GROWTH MANAGEMENT DEPARTMENT STAFF REPORT
PONTE VEDRA OVERLAY DISTRICT
March 22, 2023 Public Meeting
ARC 2022-05 Gate C-Store #1201 @ Ponte Vedra - Raze & Rebuild

To: Architectural Review Committee
Staff: Trevor Steven, Planner
Date: March 17, 2023

Summary of Request: Applicant is requesting design approval of a new Convenience Store with associated fuel tanks, canopy, parking, and signage. The project includes the demolition of the existing Convenience Store and Bank. Staff notes that the use of Convenience Store is allowable by right within the R-3 Zoning District. There are no Variance requests within this project; this application is for the architectural design review of the proposed site. The ARC is charged with determining compliance with PVZDR Sections VIII.Q.5.d and VIII.Q.5.e for architectural design elements, per VIII.Q.6.a(3).

FRONT ELEVATION

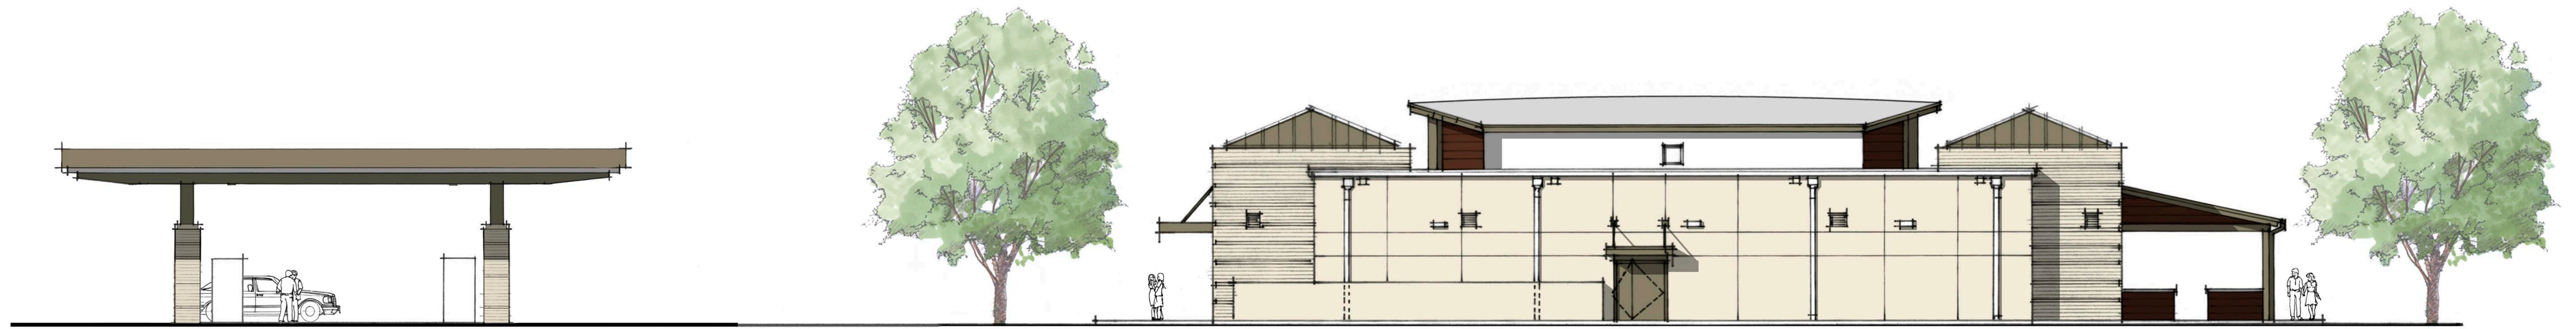
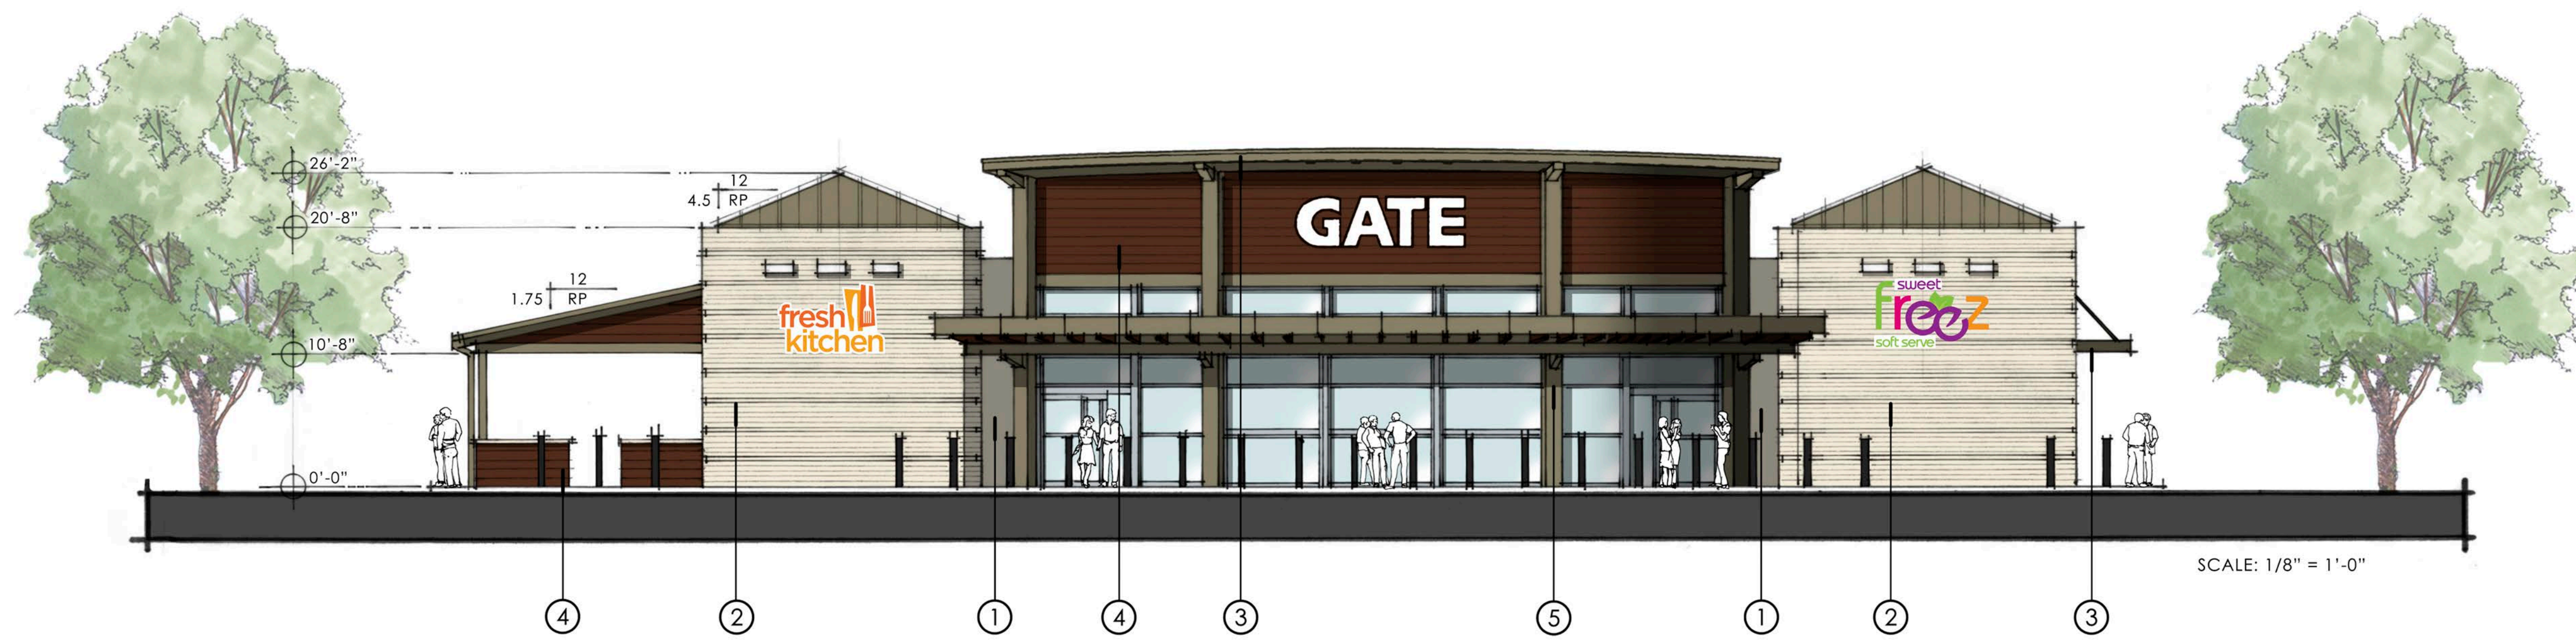
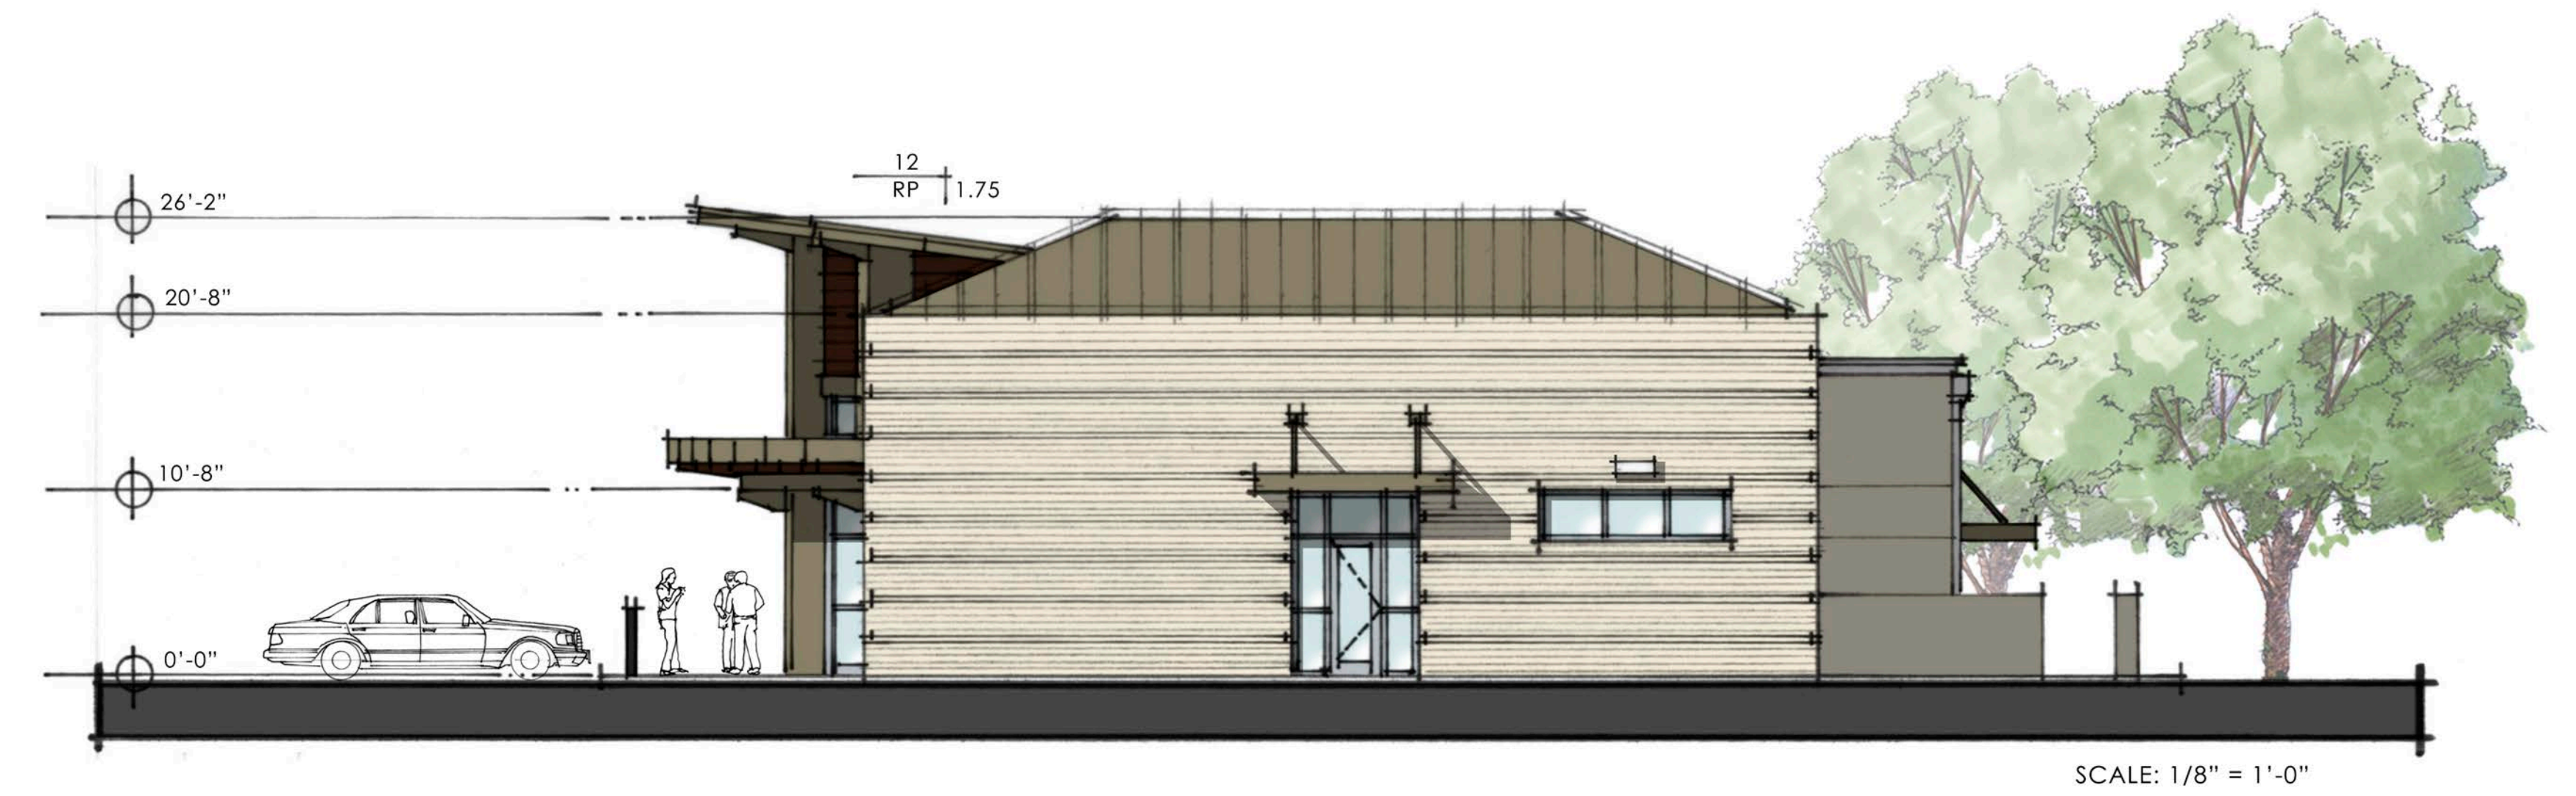
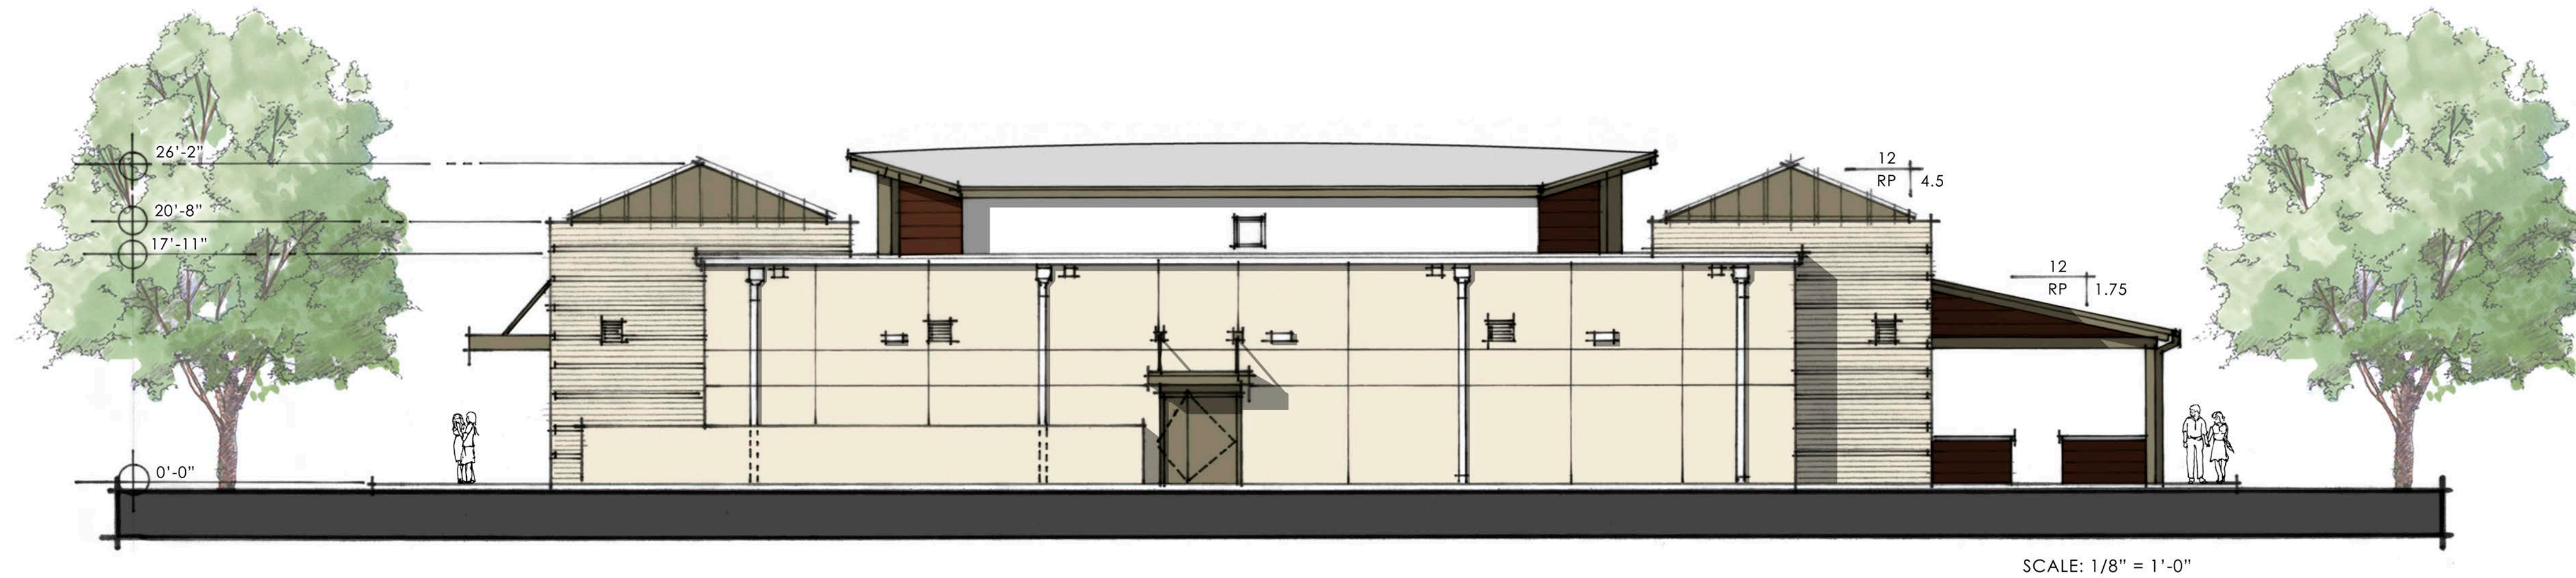
Per PVZDR VIII.Q.5.e, flat roofs, or the appearance of flat roofs, shall not be permitted. Pitched roofs, or the appearance of pitched roofs are required. The proposed building has three roofs – the two on either side appear to be hip roofs, while the middle is a pitched roof. The PVZDR does not state a required roof pitch.

The proposed colors and materials of the project appear to be consistent with the standards set forth in PVZDR Section VIII.5.d.e. Applicant states they are meeting the requirements for the color palette being no more than three colors per building, excluding roof color.

① Front Elevation and End View - Gate Main ID / Gas Price Face
3/8" = 1'-0"

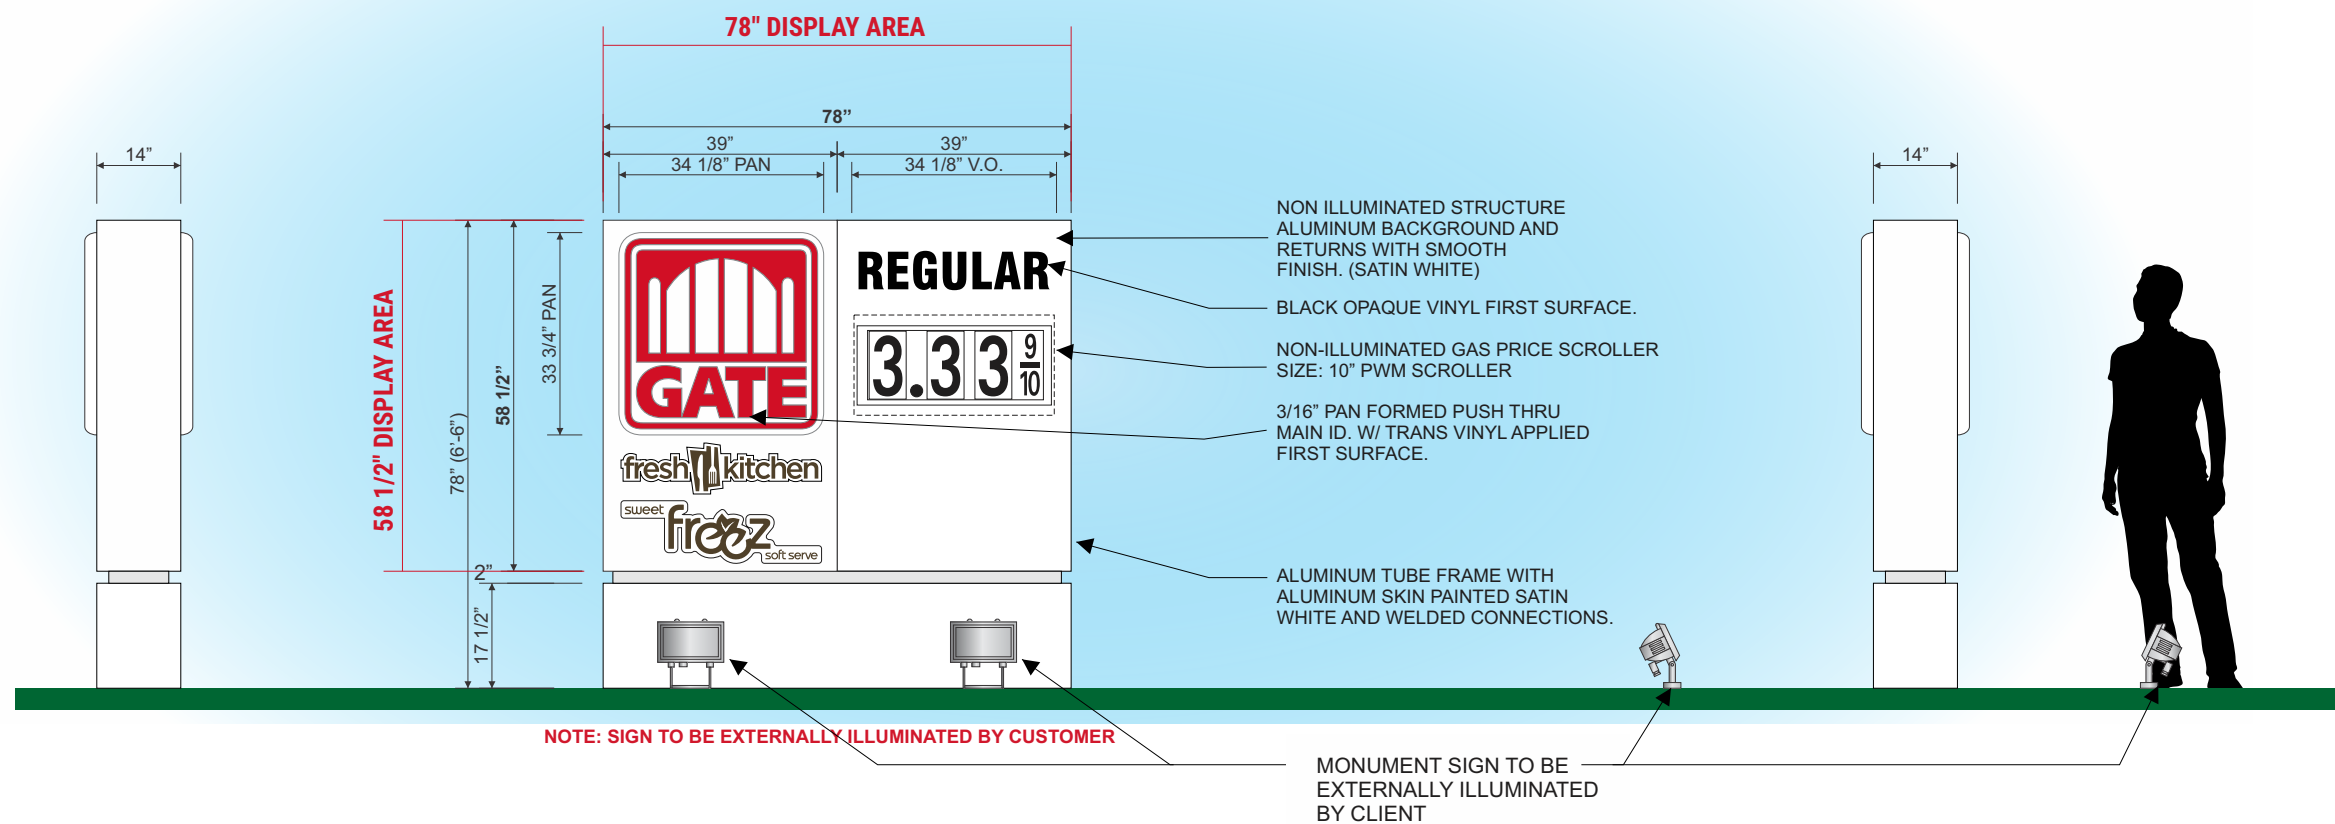
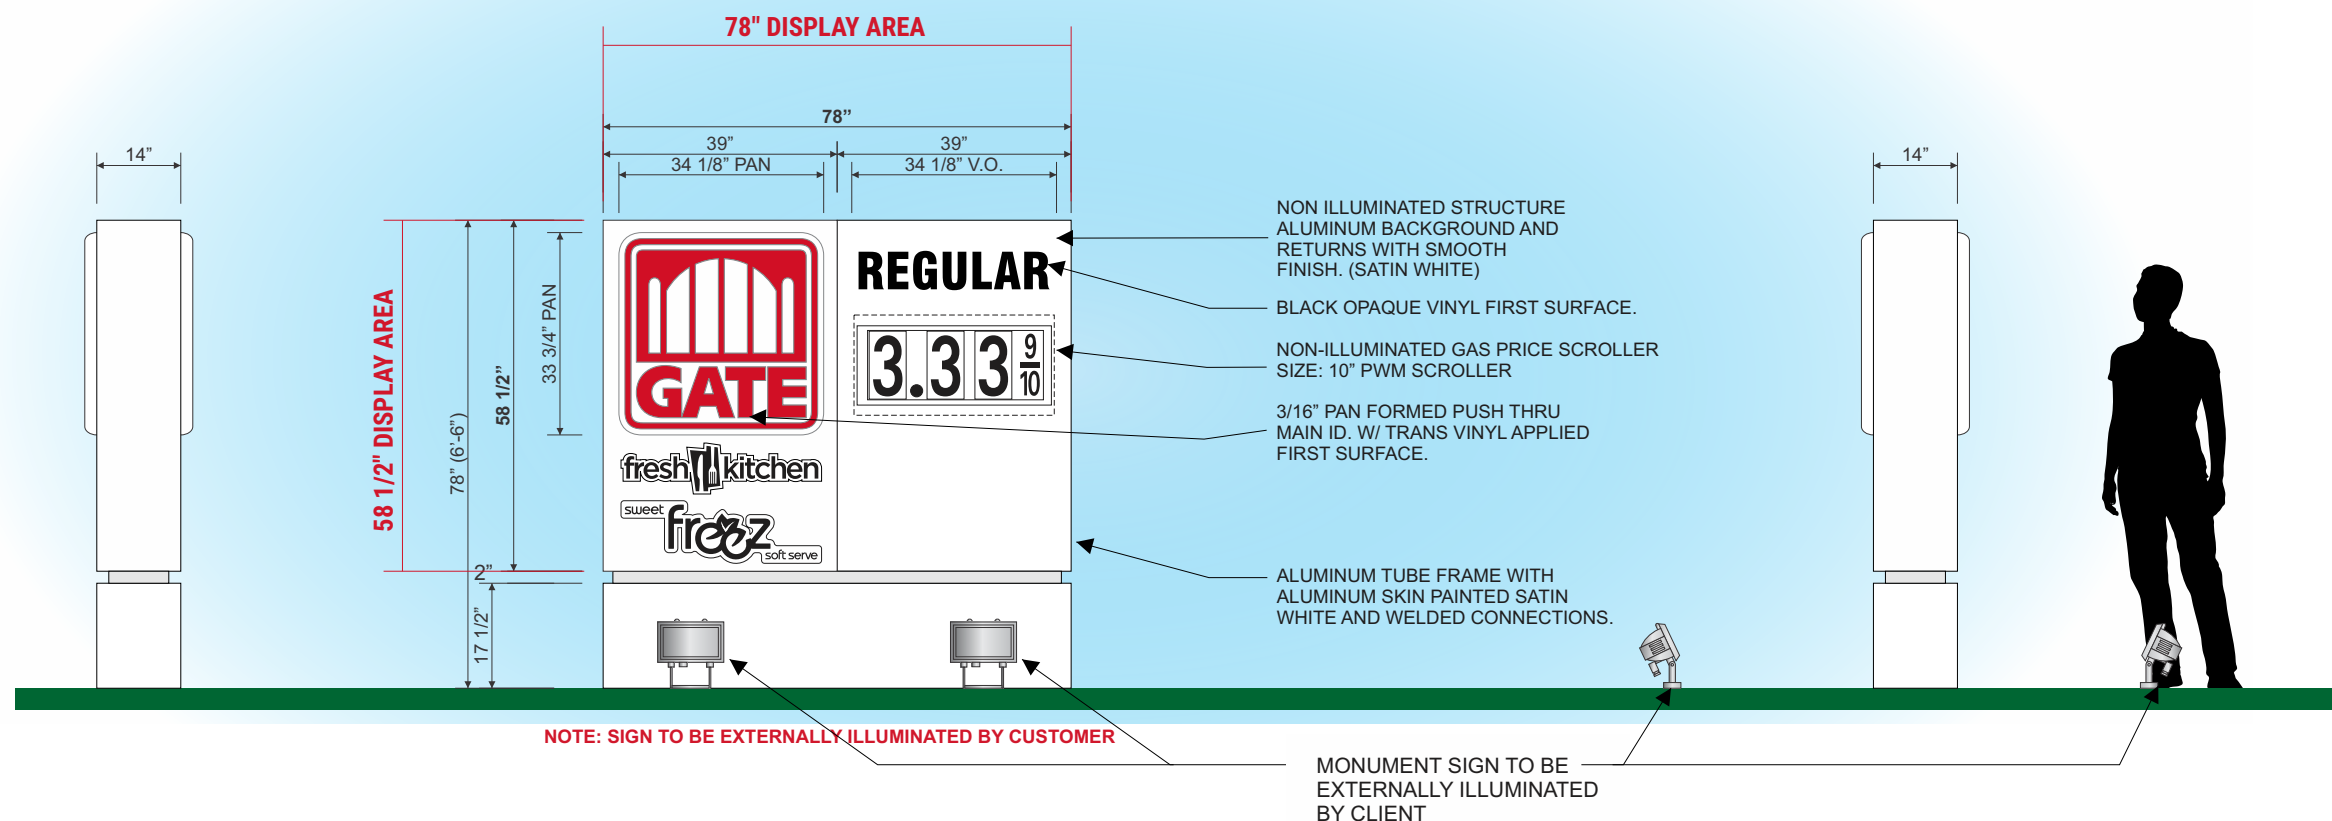
Per PVZDR Section X.C, the total wall sign area for each building shall not exceed 24 square feet per face. Where a building is divided into units for several businesses, one wall sign as specified above is authorized for each such business. The Applicant is proposing multiple face signs for this project. The “Fresh Kitchen”, “Sweet Freeze”, and “GATE” wall signs are in compliance with the regulations as stated above. Additionally, the proposed monument sign has a total of 31.7 square ft sign face, which meets the requirement of 32 square ft maximum. It appears the applicant has provided multiple sign face color scheme options for the Board to review for compliance with the Overlay District design standards.
